BARRETTS HILL LLC OSD PLAN

SB# 08-23

STAFF REPORT

May 29, 2024

SIGHT DISTANCE PLAN
SCALE: 1" = 30'

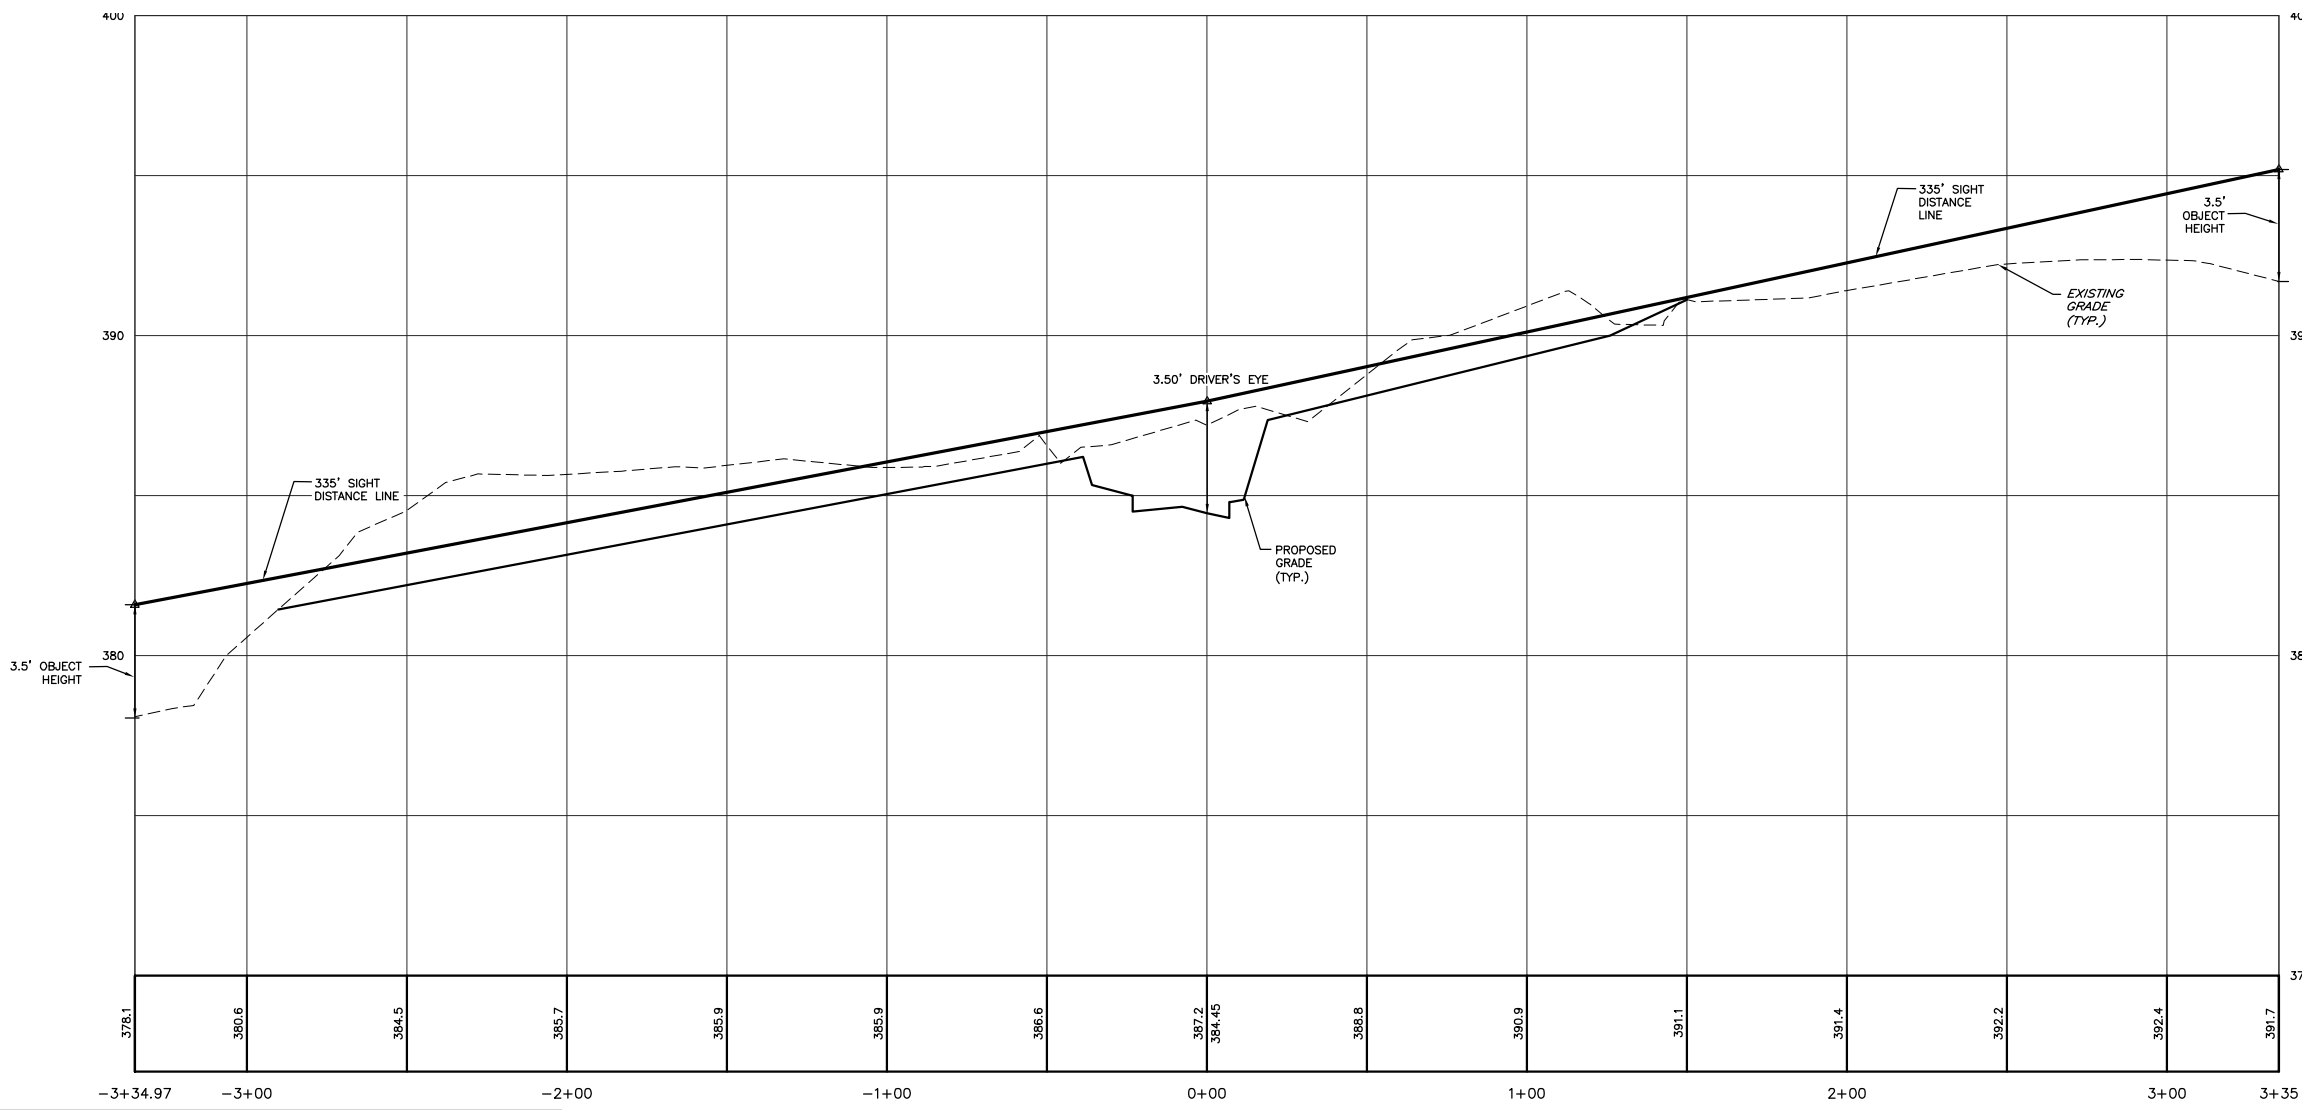
- c. *Former Fuss & O'Neill Comment: HR 193-10.E. The applicant has provided sight distance information for the proposed roadway on the plan set. The sight distance looking left (west) from Windsor Lane may be obscured by brush if not maintained and also could be significantly impacted by snowbanks during winter periods. The applicant should clarify how this area is to be maintained to provide sufficient sight distance in this direction.*

Current Fuss & O'Neill Comment: The applicant has added a sight distance easement to Lot 59-1 to ensure that sight distance can be maintained. We continue to note that in some places, the sightline is within one foot of the finished grade of the property. Any snow or brush will easily obscure the view.
